Re: DA 164-2019 Solar farm and associated infrastructure at 347 Dangarsleigh Road Armidale

Thank you for your response and request for additional information which we received on 15 February 2020. Please find below a response to each of the matters below.

PETERSONS SOLAR FARM

ARM1B - DEVELOPMENT APPLICATION

SITE ELEVATION

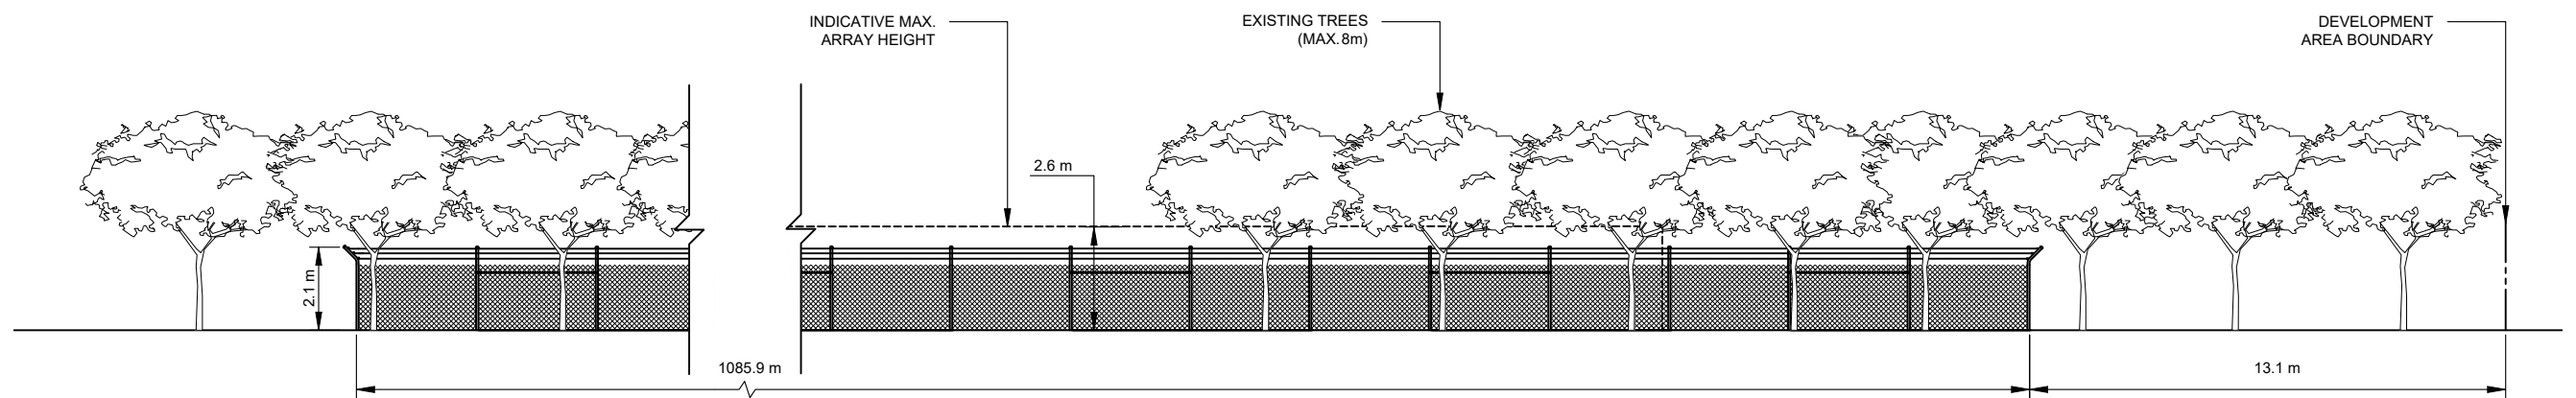
- *Proposed development on page 8 of SEE, states that the maximum height of the arrays will be 2.5m, while plans indicate that the maximum height of the arrays will be 2.617m. Could you please clarify for consistency?*

ITP confirms that the maximum height of the arrays will be 2.617m. This is consistent with the Statement of Environmental Effects which states that the peak of the modules will reach an *approximate* height of 2.5m when the array is fully tilted to 60 degrees from horizontal. Please refer to Drawing ARM1B-C-130 in the Drawing Pack attached to this submission in Attachment 1.

1 TYPICAL FOOTING PLAN
C-430 SCALE: 1:50

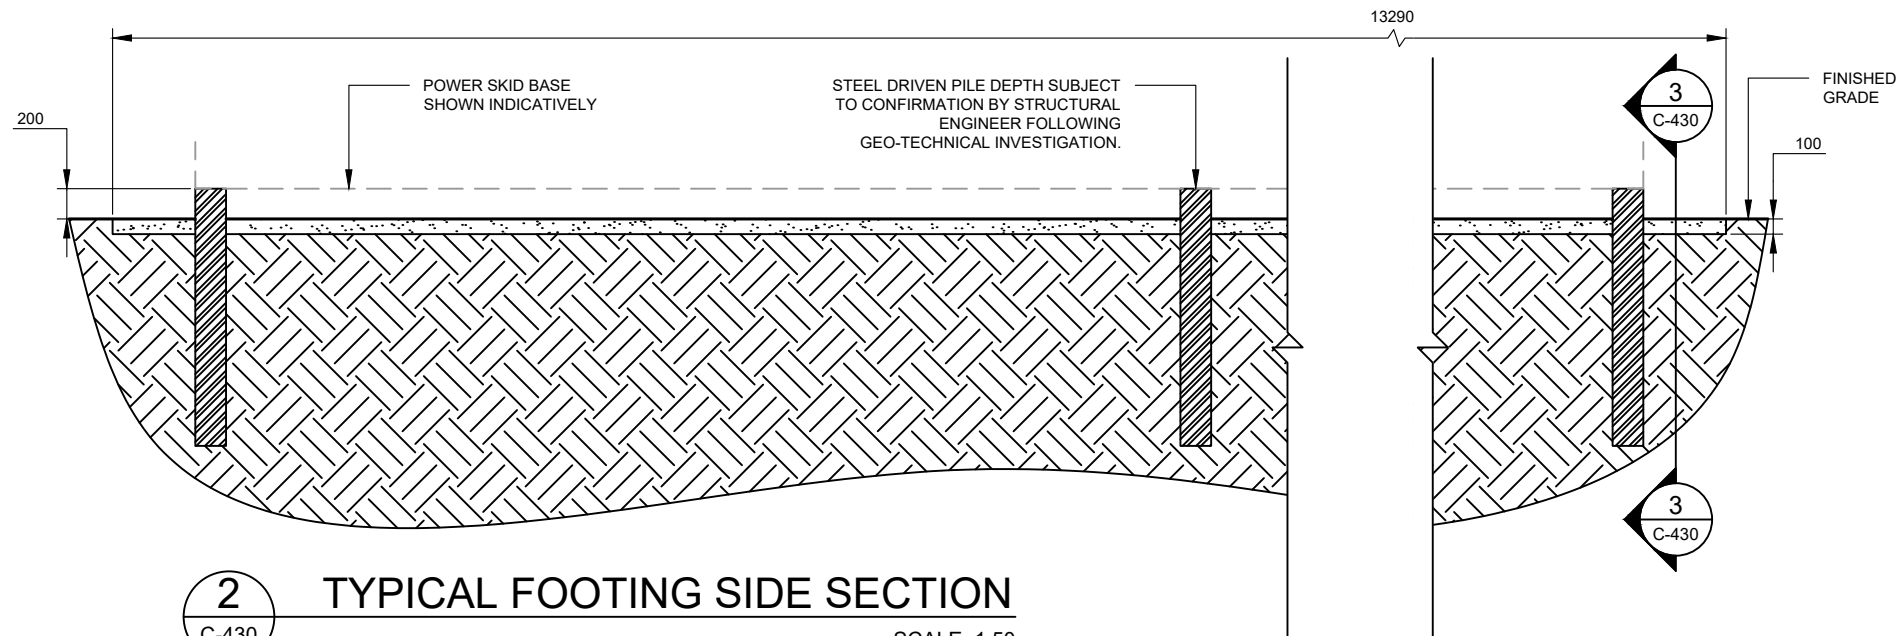
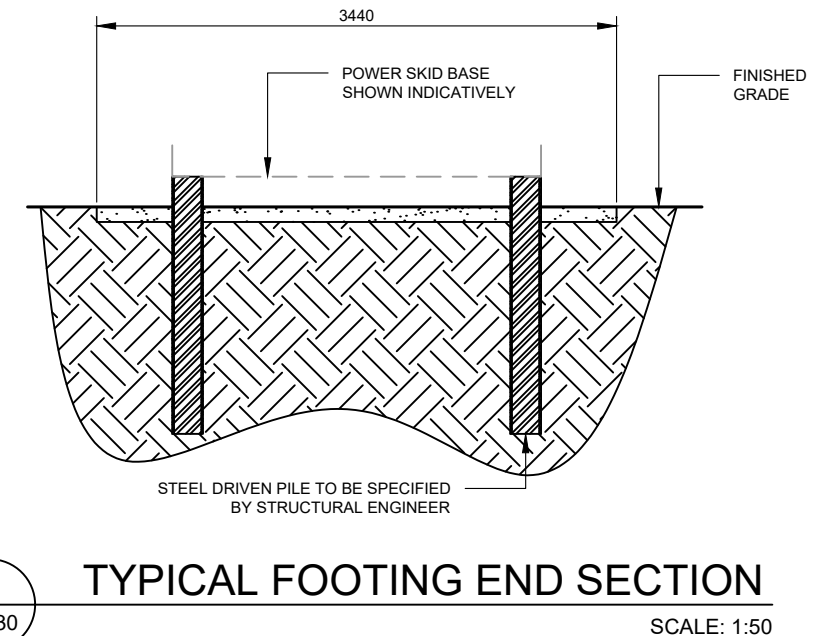
- *Please clarify construction method for mounting system for PV panels? In this regard, page 9 of SEE states that they will be constructed on piles driven into the ground approximately 1.2 to 2.5 metres, which is also consistent with the plans, but on page 16 of the SEE under earthworks it states that 1.5m footings would be required for the panel mounting frames. Again on page 60 it states 'concrete waste during setting of footings'.*

The proposed construction method is to use piles driven into the ground using a vibrating pile driver. The piles will be driven approximately 1.2 to 2.5 metres into the ground, as to be confirmed by a geotechnical and structural engineer. If the ground conditions are such that the piles are not long enough, concrete collars will be poured around the base of the piles to secure them in place.

1 PLAN VIEW
SCALE: 1:50

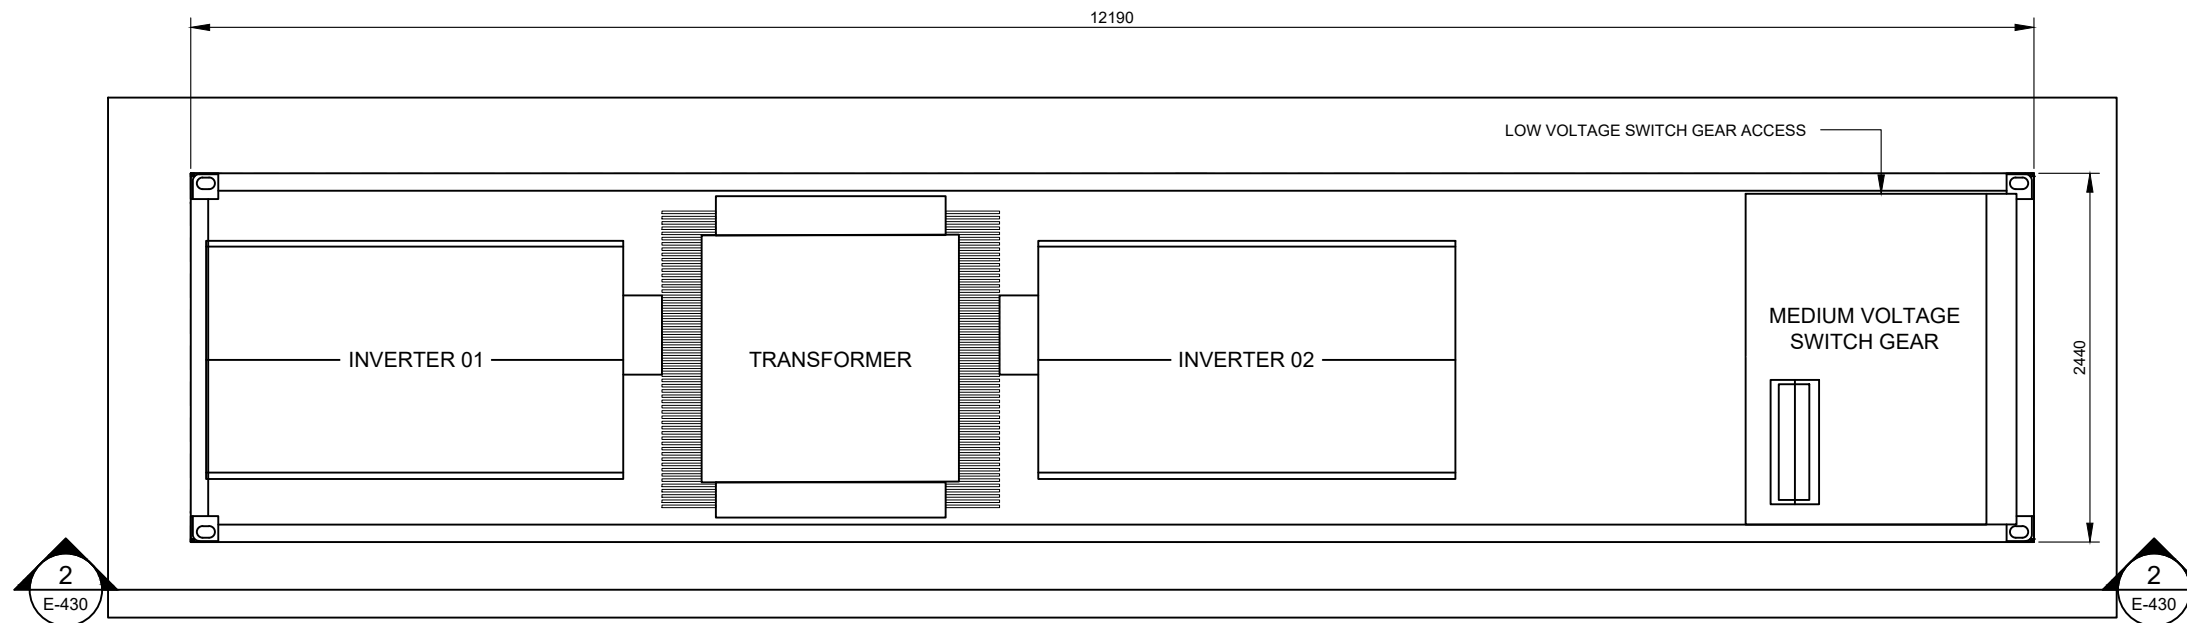
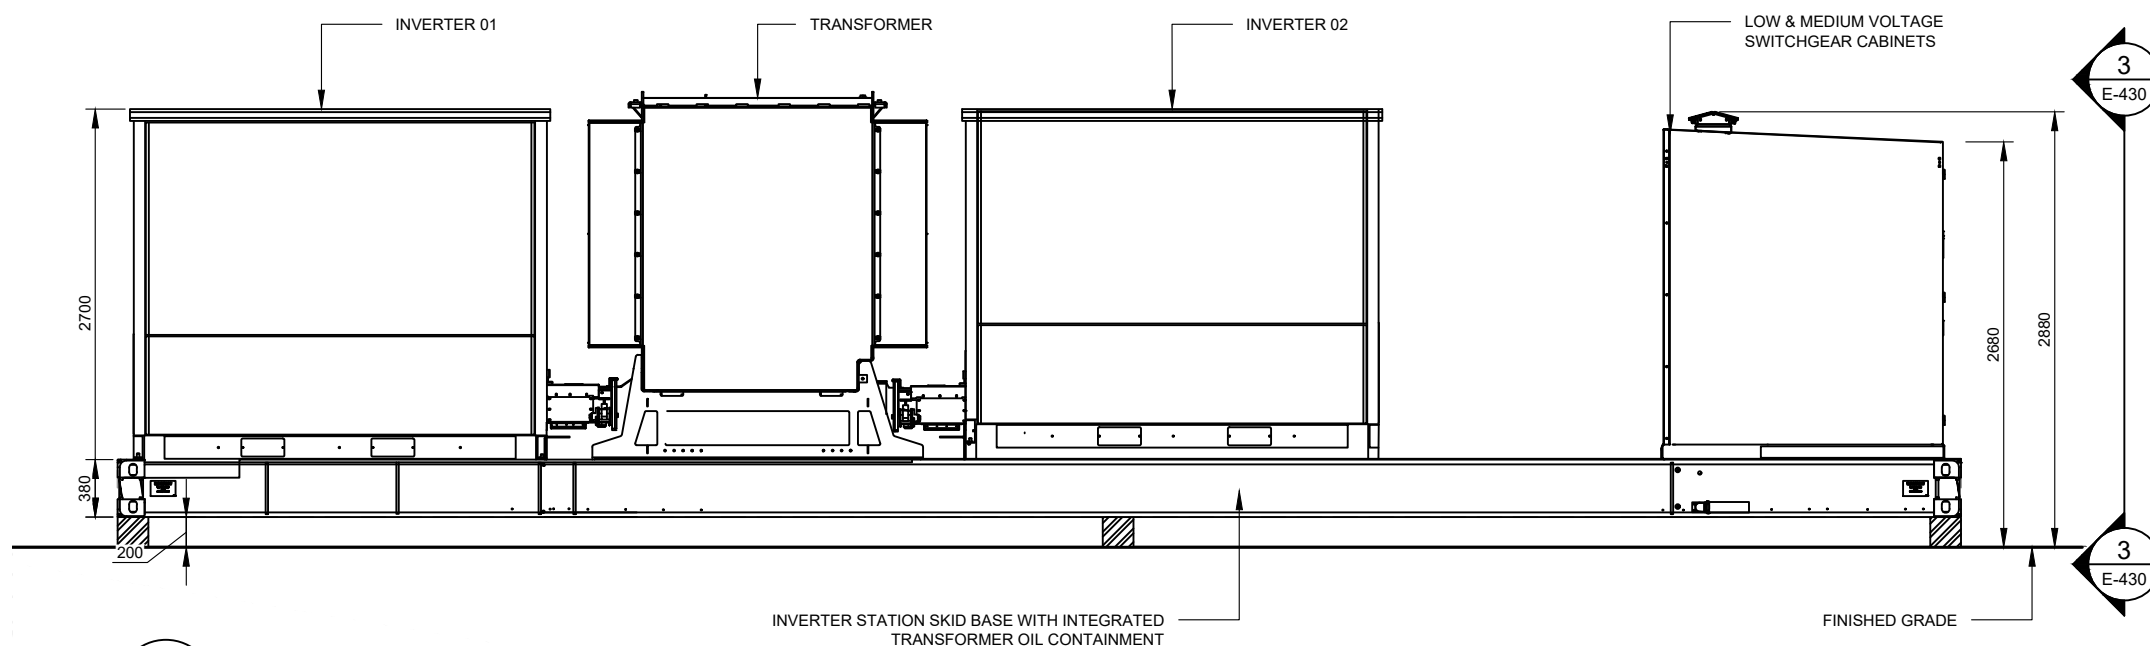
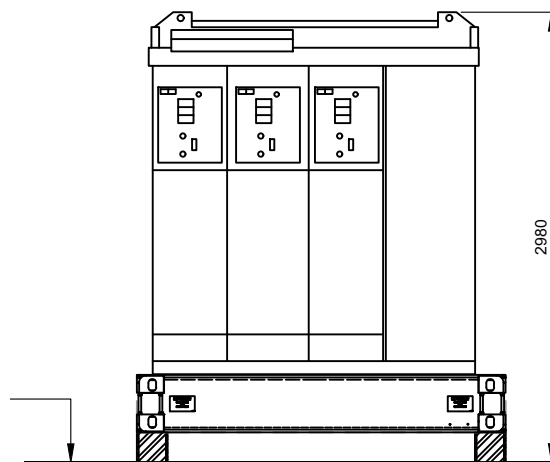
- *Page 8 of SEE states that each inverter will be mounted on a 6m long skid but submitted plan shows both inverters and transformer mounted on a 12.19m long skid. Please clarify for consistency?*

ITP confirms that the maximum skid length will be 12.19m for the two inverters and the transformer. ITP had considered locating the inverters separately on 6m skids each, however we have now confirmed the single-skid design. Please refer to Drawing ARM1B-C-430 attached to this submission in Attachment 1.

Attachment 4 – Swept Path Diagram

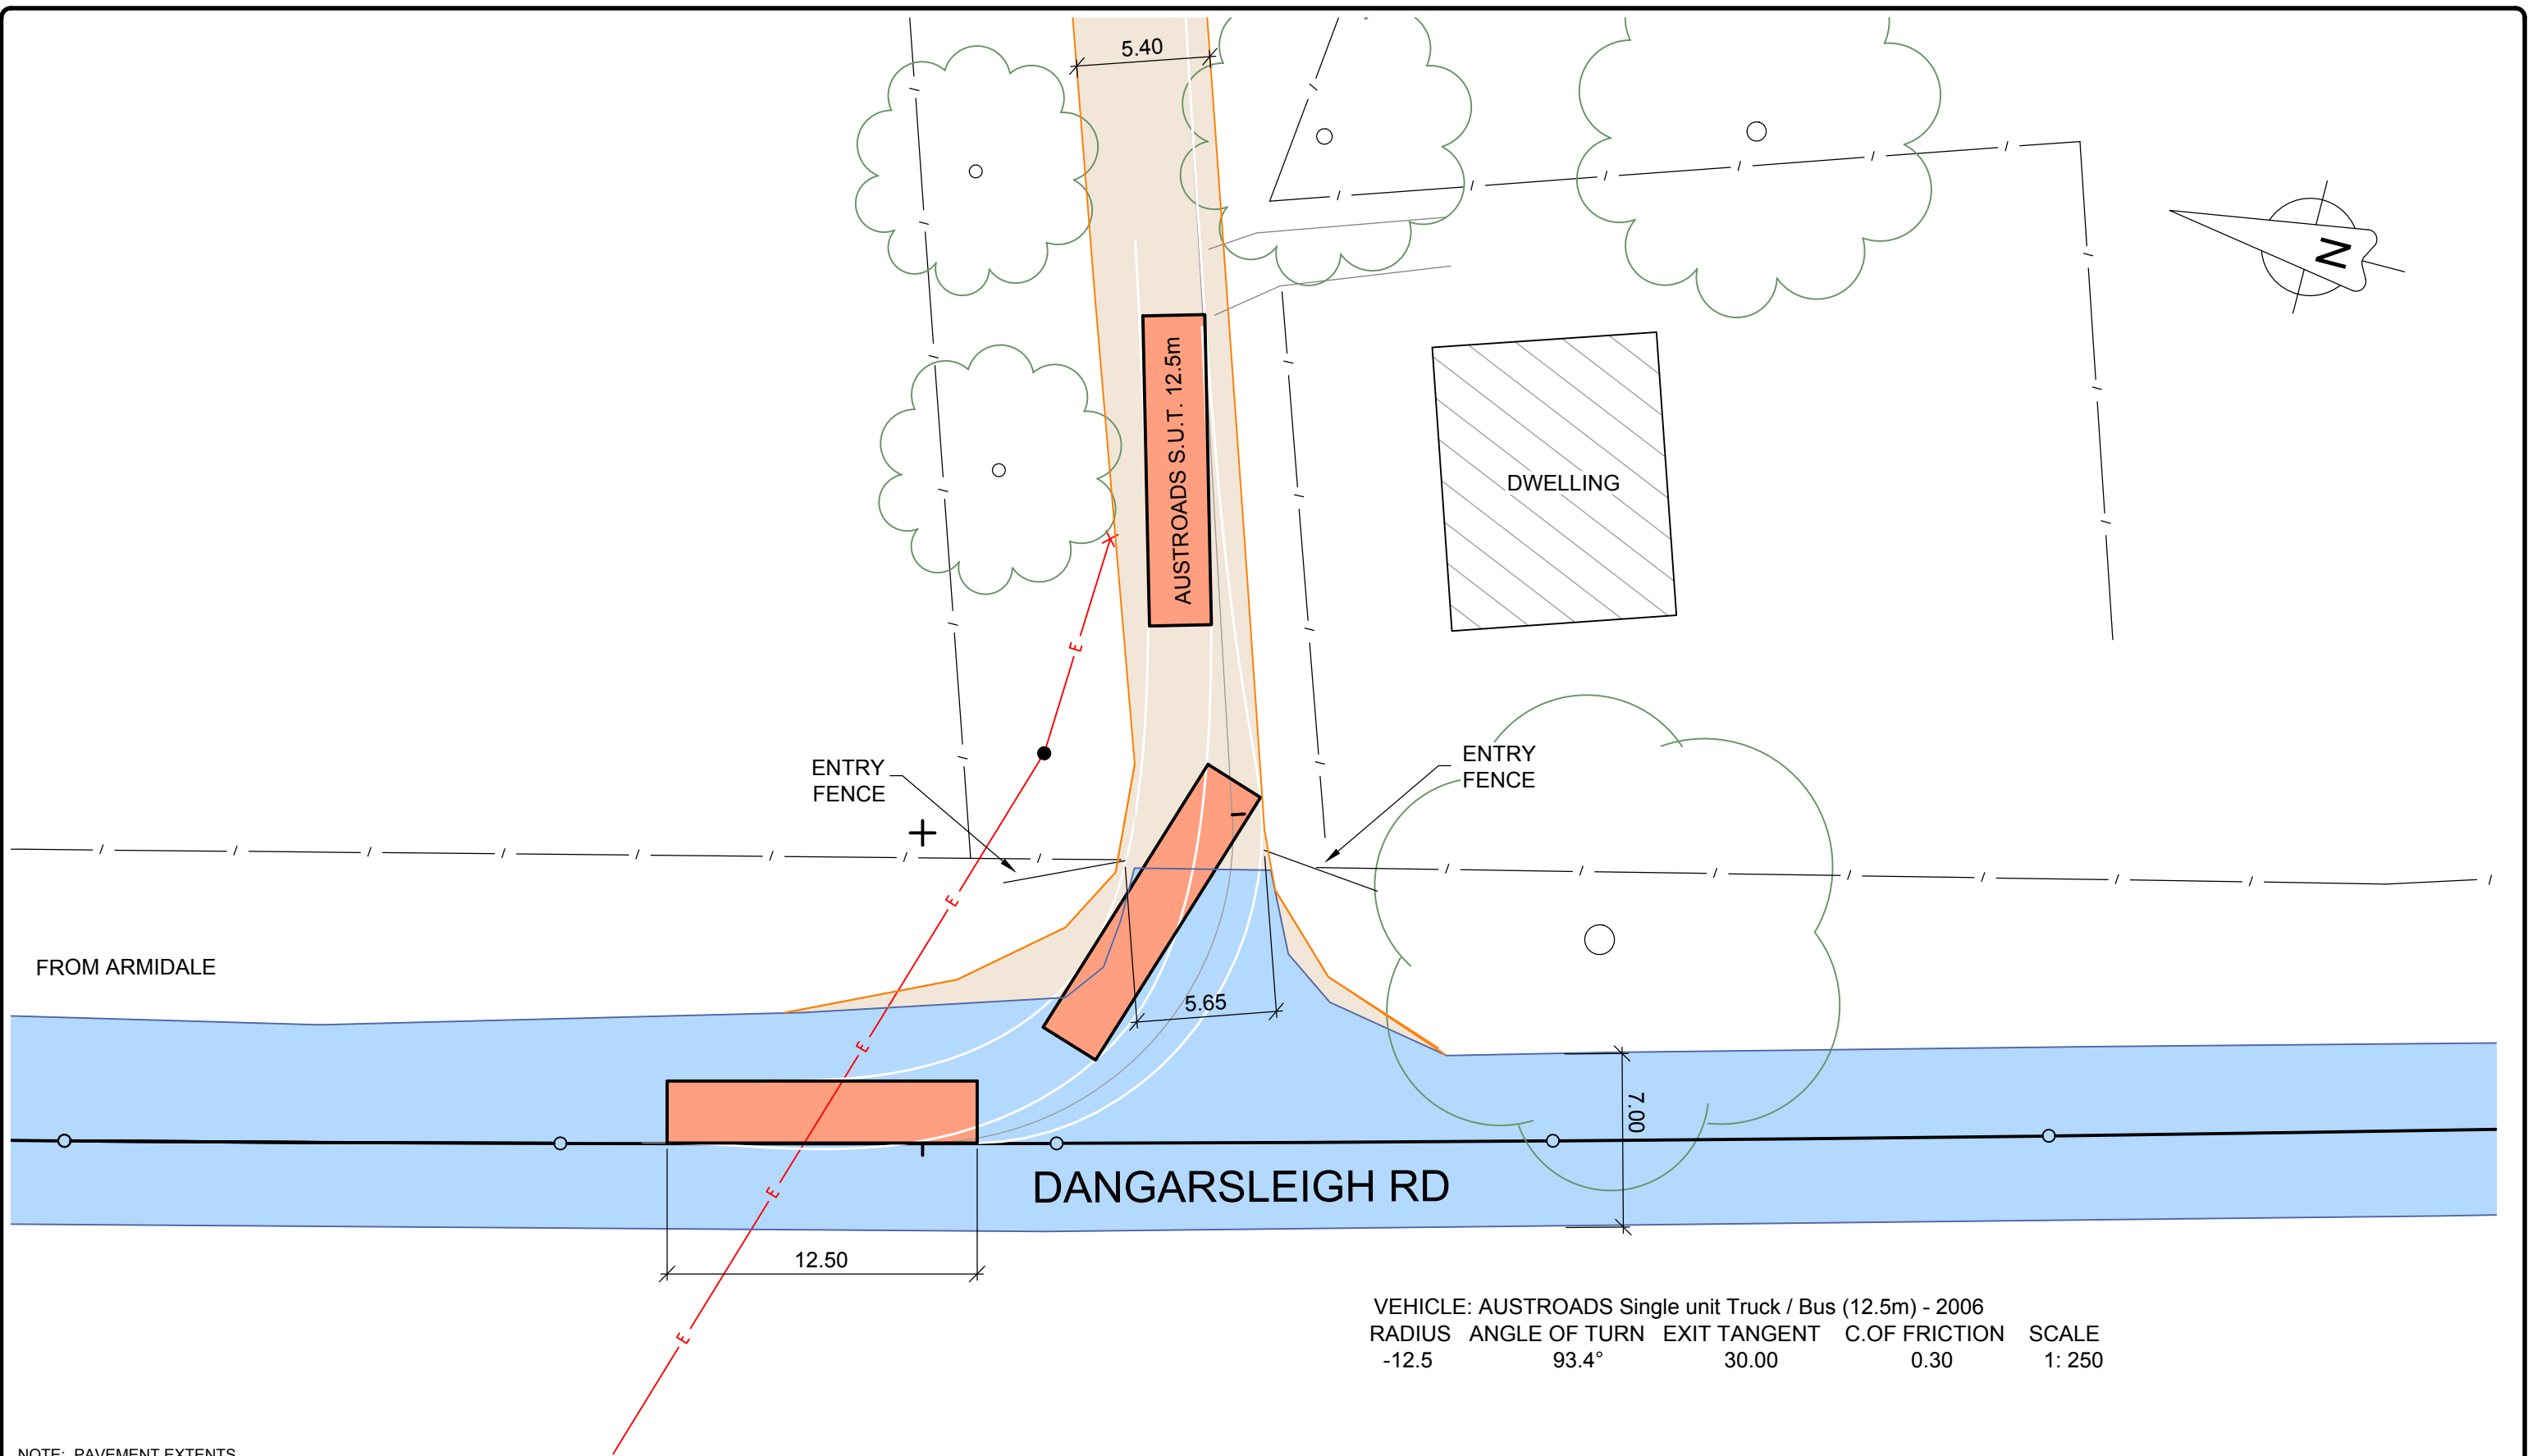
- *Please provide a swept path analysis for the largest type of vehicle proposed to be used to access the site demonstrating that they can negotiate the ingress/egress safely without any upgrades.*

ITP has commissioned our traffic consultants, New England Surveying & Engineering, to provide a swept path diagram for a single unit truck being 12.5m in length. Please refer to the diagram attached to this submission at Attachment 4.
